# CITY OF PORTLAND, MAINE

Project Name: Eleven-Unit Condominium  
Address: 161 York Street  
Applicant: York Street Redevelopment, LLC  
Planner: Shukria Wiar

Project ID: 2016-261  
CBL: 044 B006001

## PLANNING BOARD REPORT Amended for March 28th Hearing PORTLAND, MAINE

Figure 3: 161 York Street Site Plan

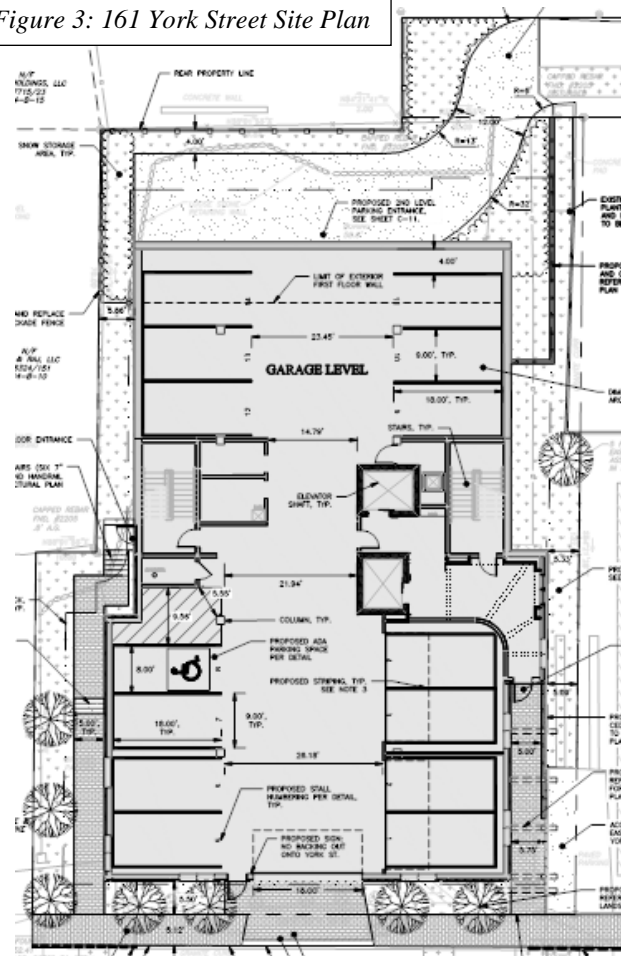
- **Curb Cut on York Street:** The Planning Board and traffic engineer sought eliminate all potential backing maneuvers from York Street due to safety concerns. The Board sought to have the applicant close the existing curb cut on York Street to the east of the site and to reduce the parking spaces on the lower level garage by at least by two spaces to enable vehicles to turn and go forward from the garage;

- Re-adjust the fence location on the site plan.

**Staff Comments:** Two of the parking spaces in the lower level garage have been eliminated, so vehicles can now maneuver within the garage and do not have to back onto York Street. The site plan now shows the curb cut on the east side closed and replaced with brick sidewalk and granite curbing. Tom Errico, Consultant Traffic Engineer has reviewed the revised plans and finds them acceptable.

Staff Comments: The revised site plan shows a fence at the rear property that wraps around the westerly corner of the property and up to the building.

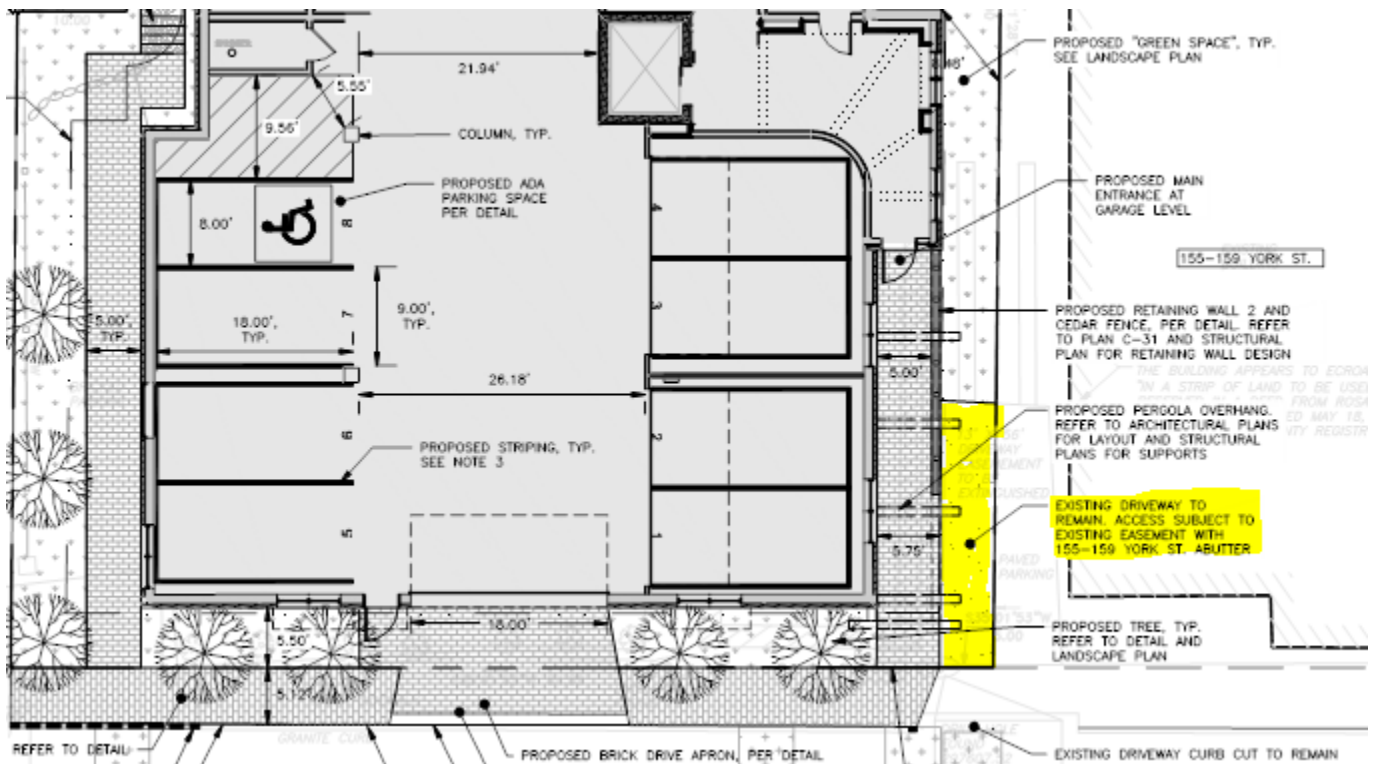
There is shared driveway between 161 York Street and 159 York Street. The subdivision and site plan for the adjoining property at 159 York Street was approved July 27, 2004. There was a condition of approval that stated that allowed a driveway for a depth of 20 feet at this location, see the condition language below:

*That the site plan be revised for Planning Staff review and approval reflecting a paved surface for the York Street driveway to a depth of 20 feet, and a surface treatment of loam and seed for the balance of the driveway easement.*
